Official Transcript of Proceedings
NUCLEAR REGULATORY COMMISSION

Title: Advisory Committee on Reactor Safeguards
 Plant License Renewal Subcommittee

Date: Thursday, November 15, 2018

PLANT LICENSE RENEWAL SUBCOMMITTEE

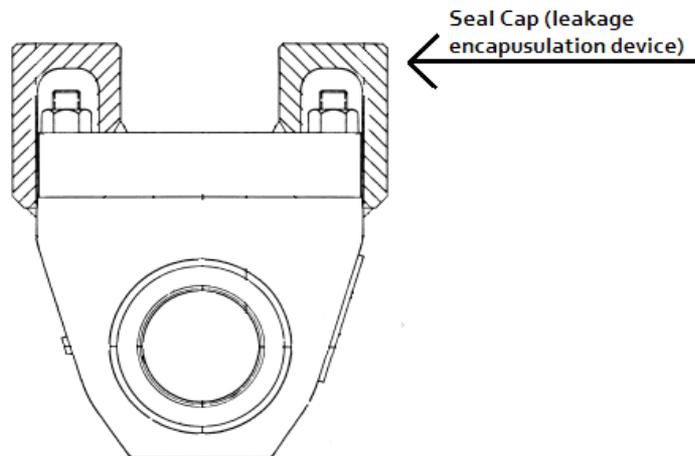
- Once a seal cap enclosure is installed, the bolting and component external surfaces within the enclosure are no longer visible for direct inspection.

Resolution

- NextEra removed the seal cap enclosure (OR15, 2012).
